GENERAL ELECTRICAL SITE PLAN

11-5-93	REVISED SYMBOLS AND HWY. I.D. TAG NOTES AND ADDED NOTE 3 & NOTE 5
DATE	REVISION
STATE OF HAWAII DEPARTMENT OF TRANSPORTATION HIGHWAYS DIVISION	
GENERAL ELECTRICAL SITE PLAN	
INTERSTATE ROUTE H-3 F.A.I. PROJECT NO. I-H3-1(69) & (70)

SHEET No. E1 OF 28 SHEETS

MANHOLE AND PULLBOX LAYOUT DETAILS

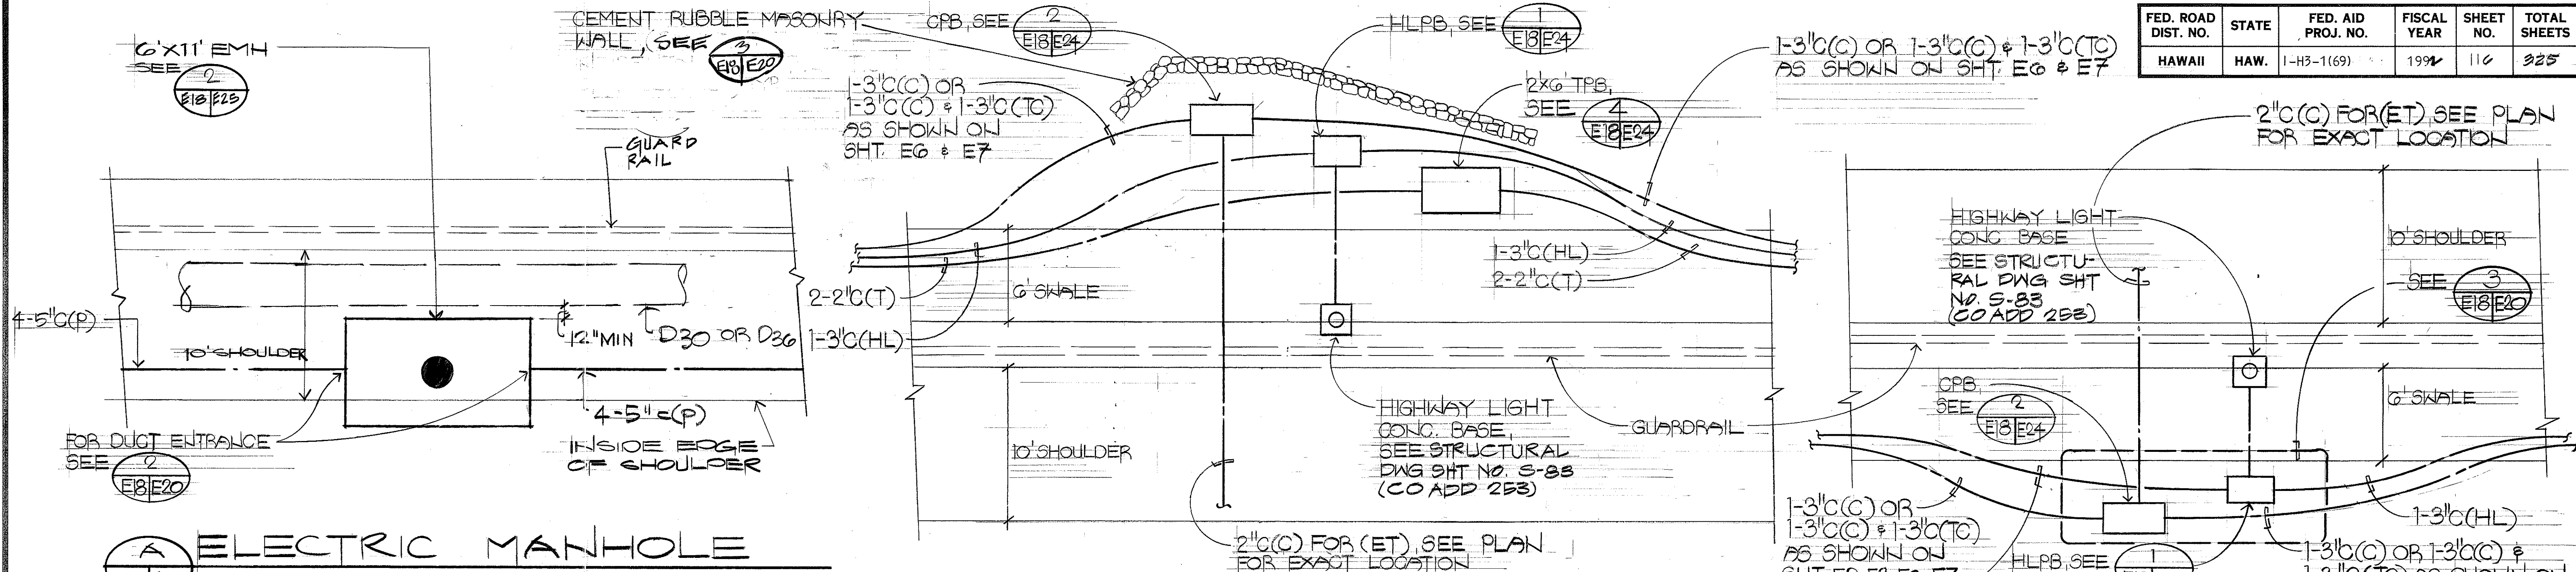
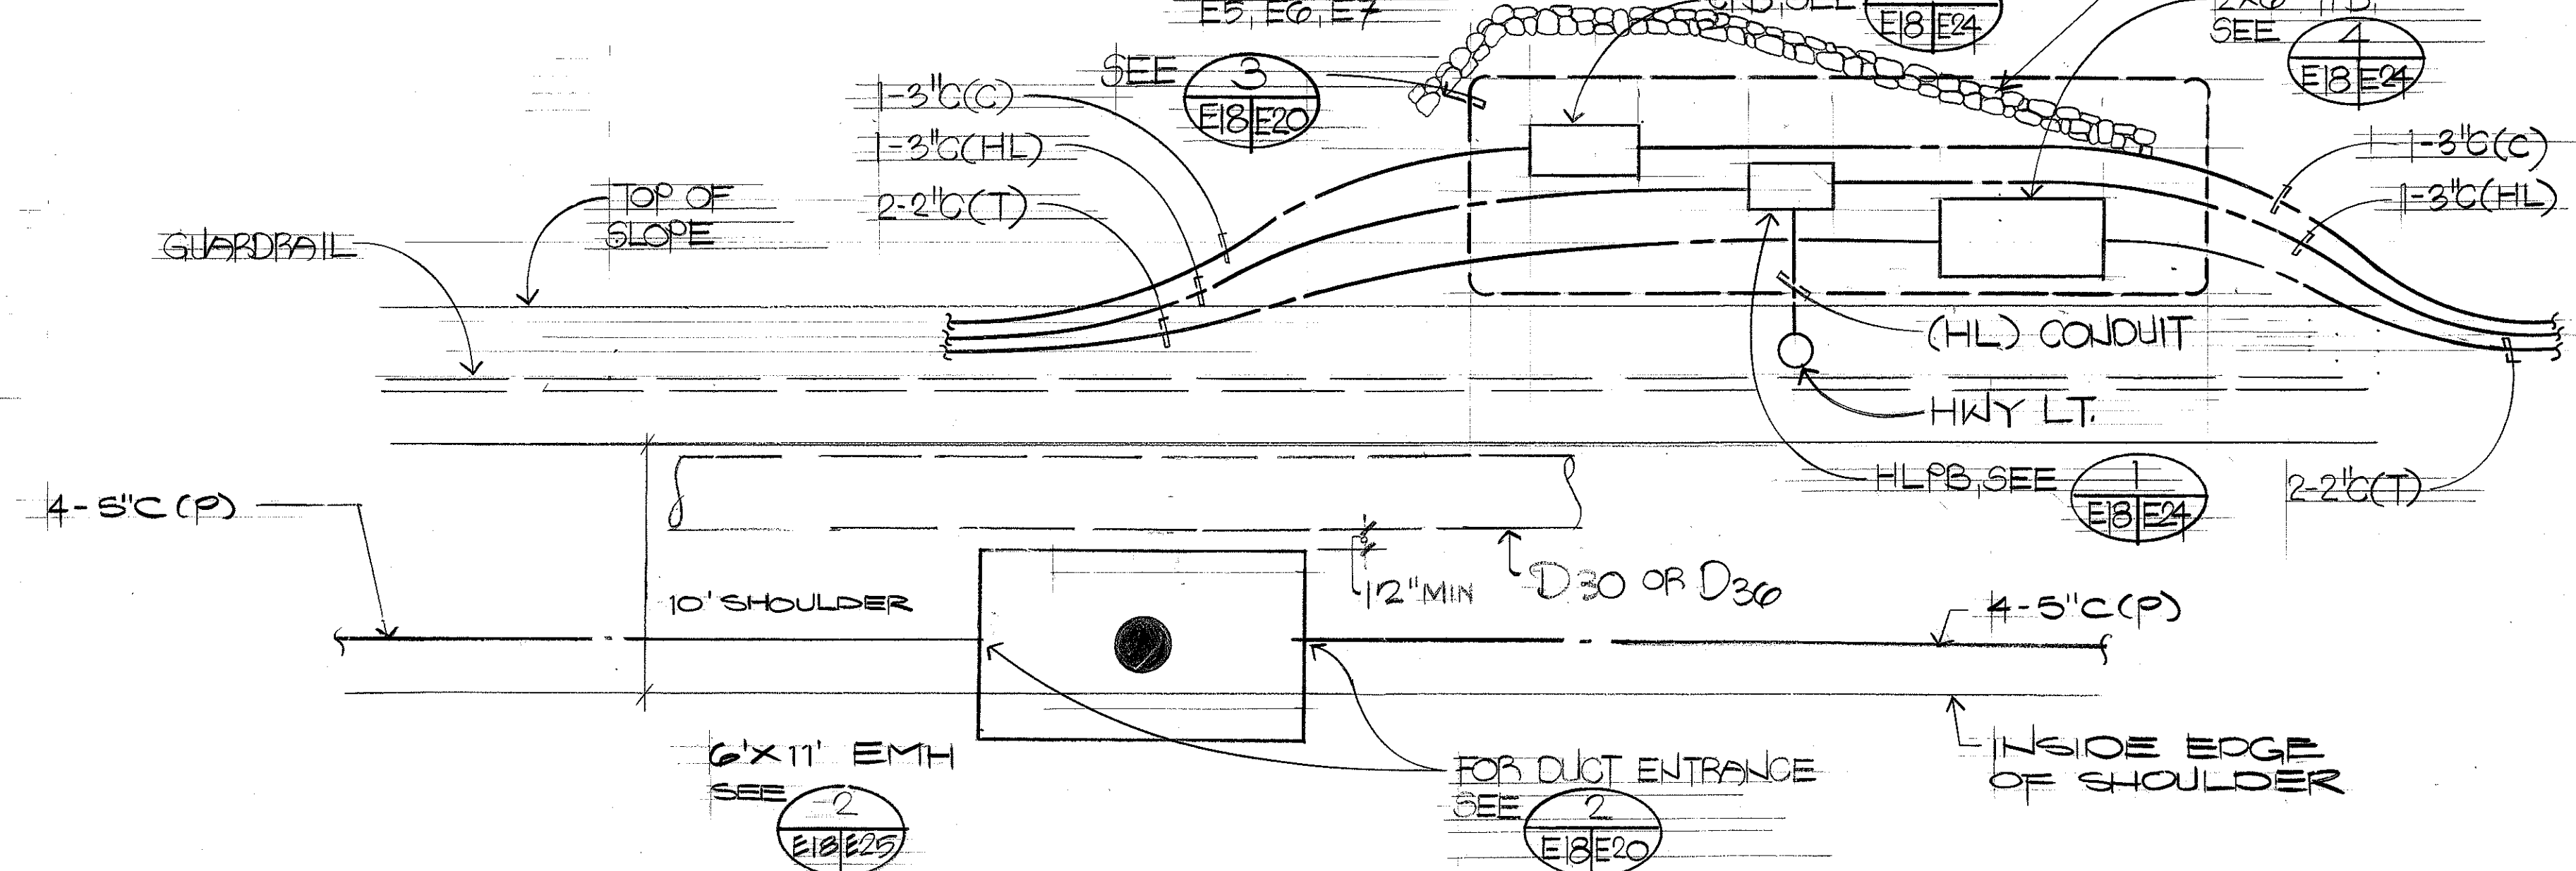
04-29-96	REVISED ST LITS CONCRETE BASE DETAIL REFERENCE
11-5-93	ADDED CEMENT RUBBLE WALL IN DETAIL B AND ADDED REF. 3/E20 IN DET. B AND F
DATE	REVISION

SHEET No. E20 OF 28 SHEETS

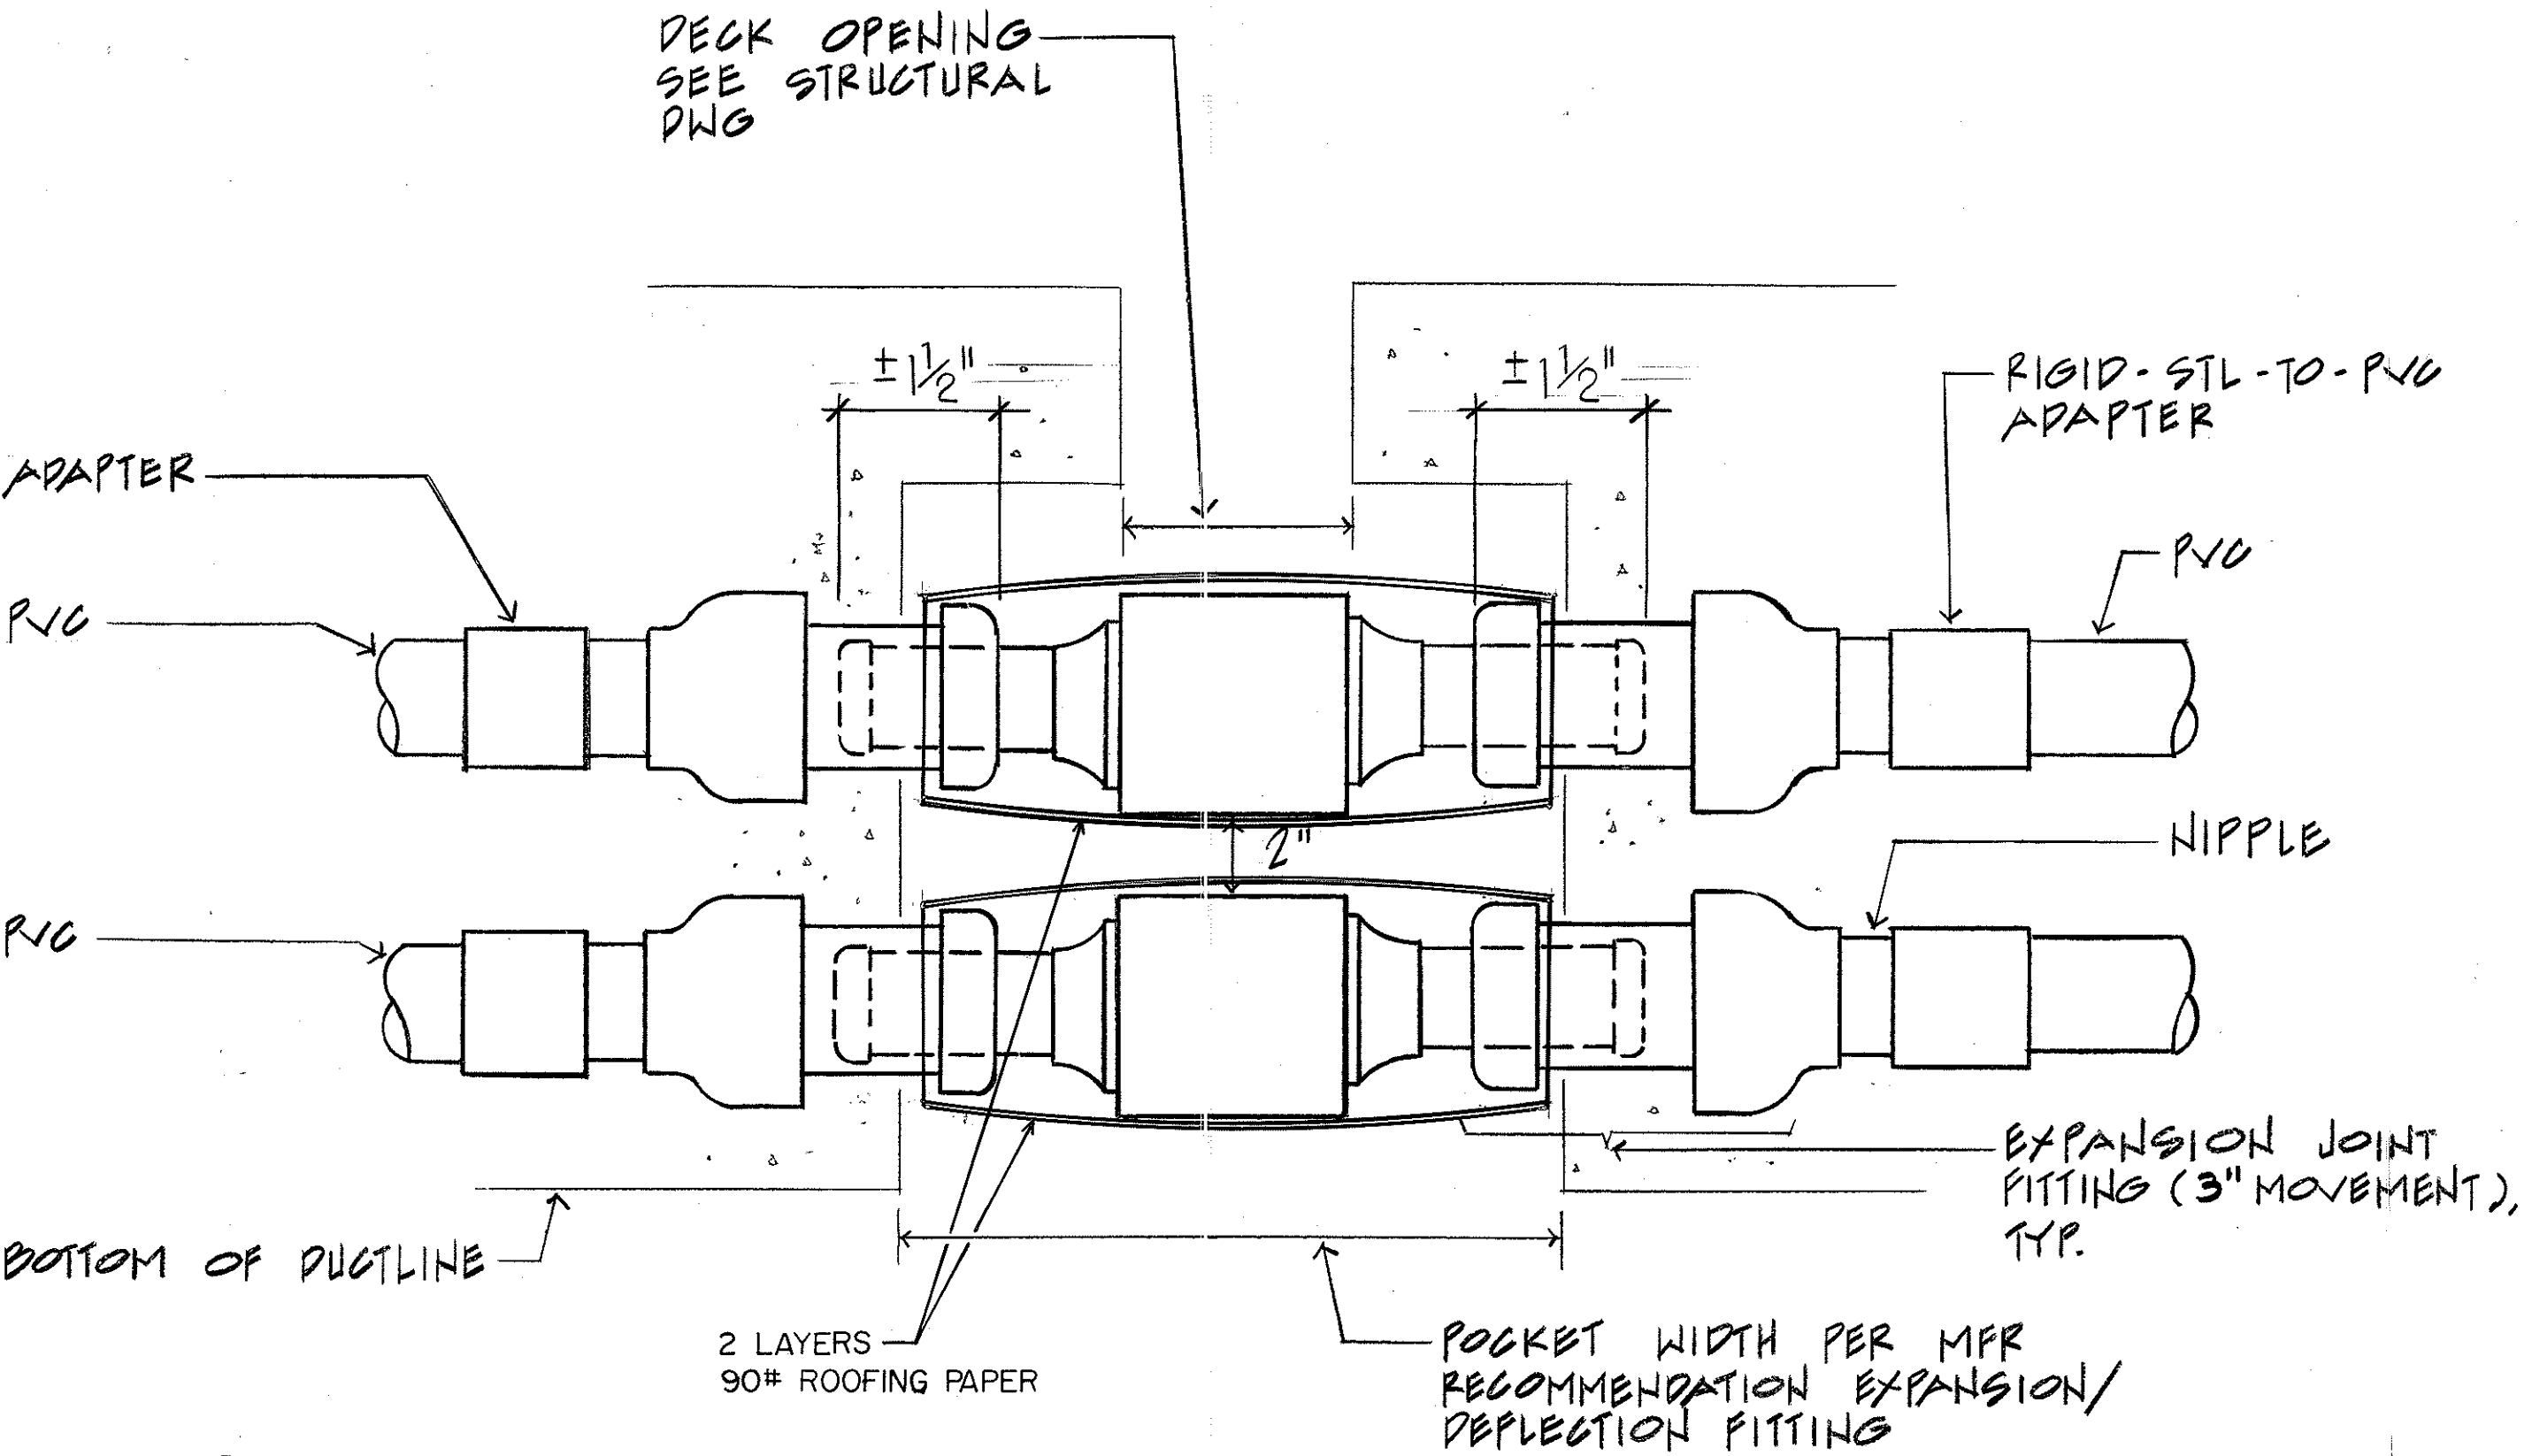
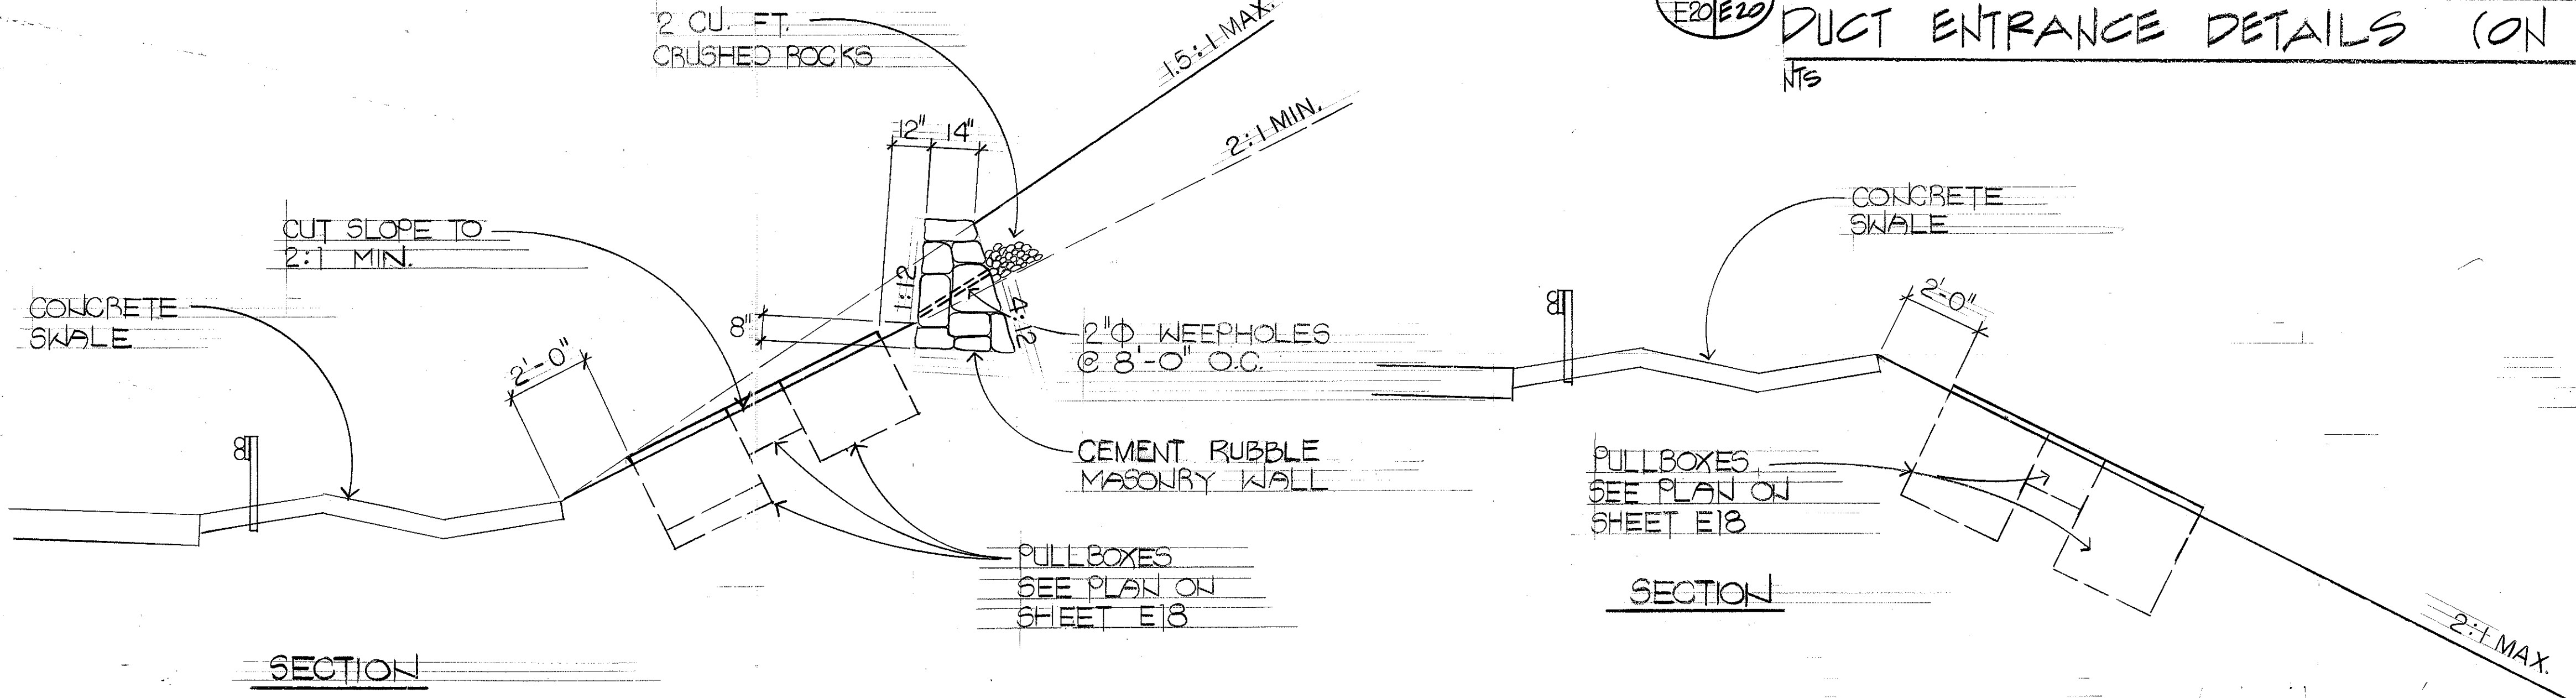
7-15-94	INDICATED LENGTH OF EXPANSION IN DET. 1 AND REVISED PULL IRON AND ADDED SUMP NOTE IN DET. 2
11-5-93	ADDED DETAIL 3
DATE	REVISION
